ADDENDUM NO. 2

**JOB NO. J45CO49B**  
DIAMOND HEAD STATE MONUMENT  
ROCKFALL MITIGATION – PHASE 2 (FY2015)  
HONOLULU, OAHU, HAWAII

May 26, 2016

**Figure 1.** Approximate limits of shotcrete noted in red.

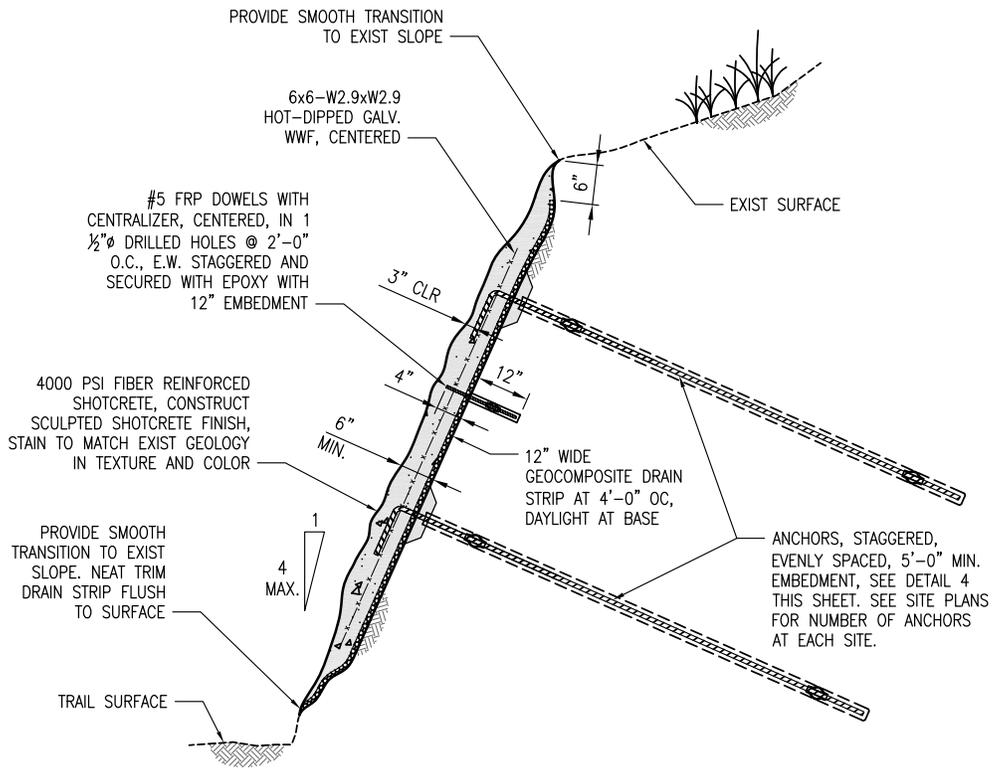
- b. Site 15; **ADD** the attached Figure 1 to clarify the up-trail limit of shotcrete.
  - c. Mitigation Schedule; **DELETE** the shotcrete description for Site 15 and replace with the following:  
 “APPROX. VOLUME = 37.0’ x 10.0’ x 0.67’  
 13 ANCHORS, 5’ EMBEDMENT, SEE DET 3/C-7, SIM”

SITE 16 - SCALING, SHOTCRETE, ROCK DOWELS

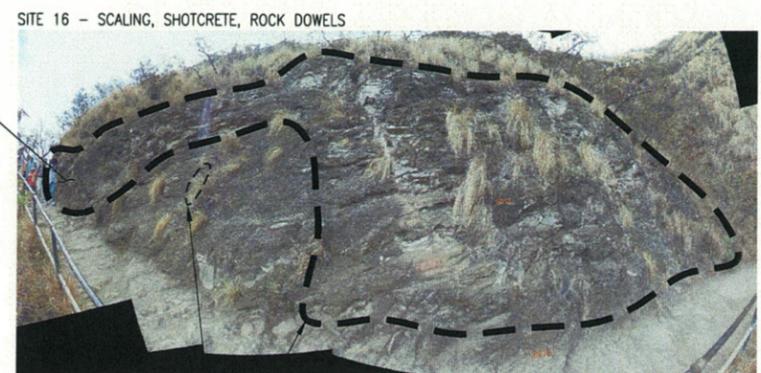
3. Sheet C-5;
- a. Site 16; **REVISE** Limits of Shotcrete callout to read as follows:  
 “LIMITS OF SHOTCRETE  
 APPROX. VOLUME = 83.0’ x 16.0’ (AVG) x 0.50’  
 42 ANCHORS, 5’ EMBEDMENT  
 SEE DETAIL 2, SHT C-7”

SITE 17 - SCALING AND SHOTCRETE

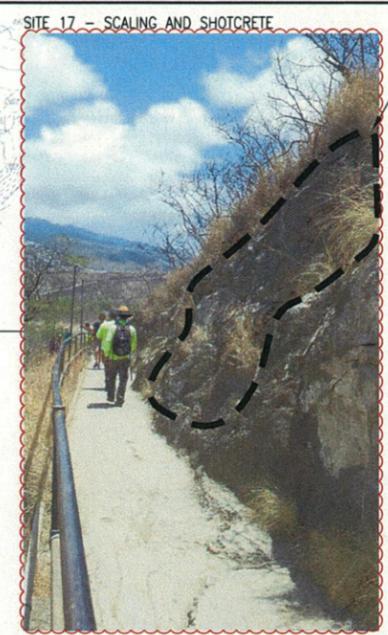
- b. Site 17; **REVISE** the Limits of Scaling and Shotcrete callout to read as follows:  
 “LIMITS OF SCALING AND SHOTCRETE  
 APPROX. VOLUME = 30.0’ x 8.0’ x 1.0’  
 11 ANCHORS, 5’ EMBEDMENT  
 SEE DETAIL 3, SHT C-7”.

- c. Site 17; **REVISE** the Limits of Scaling and Shotcrete boundary in the photograph as shown in the attached Figure 2.
  - d. Mitigation Schedule; **DELETE** the shotcrete description for Site 16 and replace with the following:  
 “APPROX. VOLUME = 83.0’ x 16.0’ x 0.50’  
 42 ANCHORS, 5’ EMBEDMENT, SEE DET 2/C-7, SIM”

2 SHOTCRETE SECTION - SLOPE, TYP.  
C-7 NOT TO SCALE

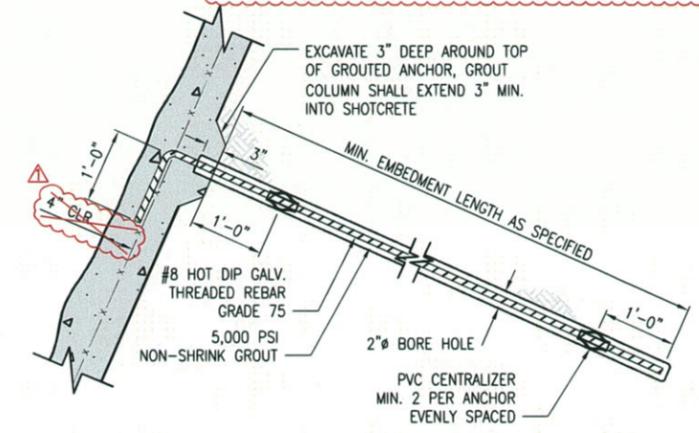
4. Sheet C-7;
- a. Shotcrete Section – Full Slope Detail; **DELETE** detail in its entirety and **REPLACE** with the attached Sketch No. 1.
  - b. Anchor Detail; **DELETE** 4” CLR dimensional callout.

- Regarding Detail 2/C-7, the bottom trenches will be very difficult to construct and also will reduce the width of the trail.
  - *Detail 2/C-7 has been revised. See revised detail attached.*

- Regarding Detail 2/C-7, does saw cutting need to go through all 2 feet of depth for the excavation at the top?
  - *Detail 2/C-7 has been revised. See revised detail attached.*

- Regarding Detail 2/C-7, after the bottom trench is excavated it may be open for a while before installing concrete. Will it be OK to cover with plywood or other method if the trail has to be opened before it's filled?
  - *Detail 2/C-7 has been revised. See revised detail attached.*
